# Wollongong Local Planning Panel Assessment Report | 11 May 2021

<b>WLPP No.</b>	Item 5
<b>DA No.</b>	DA-2020/290/A
<b>Proposal</b>	Residential - multi dwelling housing - demolition of existing dwelling, tree removals and construction of three (3) attached 3 storey dwellings over basement parking area.  Modification A - amend condition 6 (a) – Sandstone Wall
<b>Property</b>	342-344 Lawrence Hargrave Drive, THIRROUL NSW 2515 Lot B DP 378330
<b>Applicant</b>	Illawarra Property Holdings Pty Ltd
<b>Responsible Team</b>	Development Assessment and Certification - City Wide Team (BM)

The proposal is for modification of Condition 6a of the consent in relation to capacity for dismantling and reconstructing the front sandstone boundary wall. The approved development is for demolition of existing dwelling, tree removals and construction of three (3) attached 3 storey dwellings over basement parking area. The sandstone wall whilst being a local landscape feature is not heritage listed.

\*Attached: Plan and Elevation of wall illustrating the over excavation required.

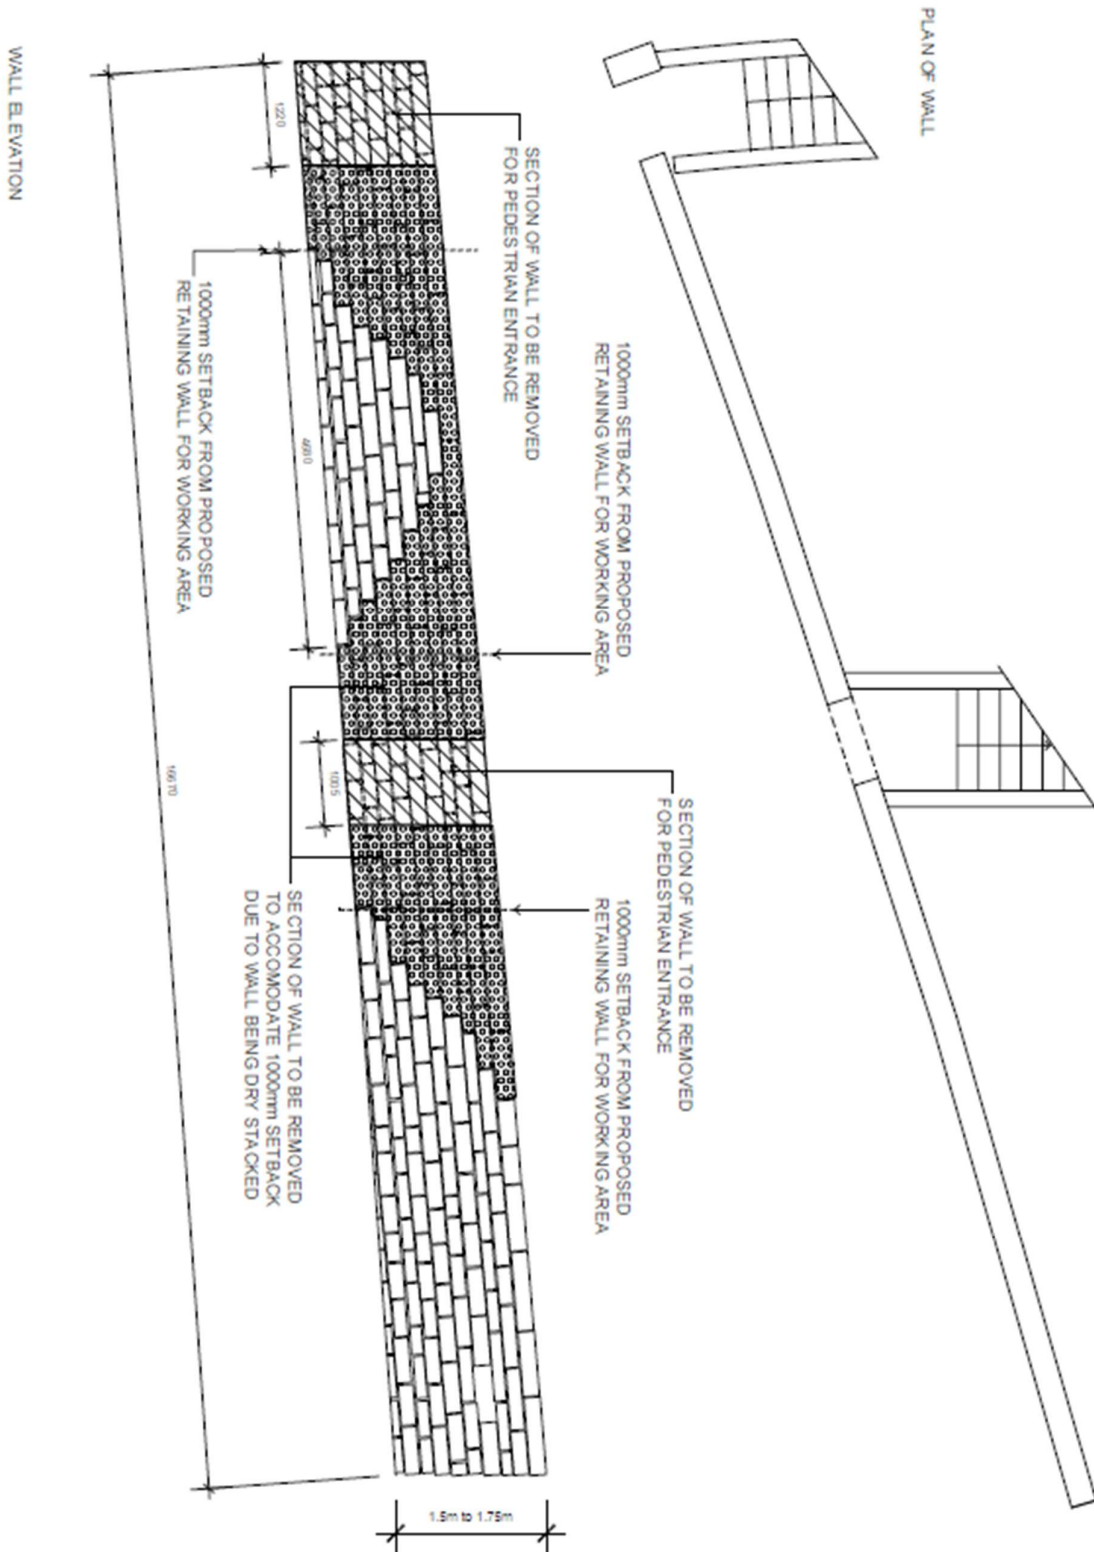
It is understood that retaining the entire wall during the construction of the proposed development is not possible and substantial portions of the wall need to be removed in order to install two openings in the wall for access to the proposed units. As part of this demolition, over excavation will be required to provide a construction zone at the back of the retaining walls. Refer to the attached plan and elevation that illustrates this.

In its current form the structural adequacy of the wall could not be guaranteed or certified. It may also be unsafe to have a stacked stone wall adjacent to the boundary while work is being carried out on the property and the footpath is open to the public.

We recommend that the retaining wall be carefully removed. Being a dry stacked wall this should not be difficult to achieve while ensuring that no damage occurs to the blocks. The construction of the retaining wall should be recorded which would allow future assessment of the existing construction to be carried out. If the wall does not conform to current Australian Standards for Structural Adequacy, a design can be provided to ensure the wall is reconstructed in a way that the wall looks the same as it was before dismantling but conforms to the current Australian Standards, this could include using additional blocks at the base to provide additional weight or adding no fines concrete. New drainage could also be added to ensure excessive pressure does not build up behind the wall. Before reconstruction of the wall, the foundation material should be assessed by a geotechnical engineer. We expect that the foundation would need improving prior to re-construction of the wall. With the usual process of a certified design and inspections carried out during construction the entire retaining wall could be certified for Structural Adequacy.
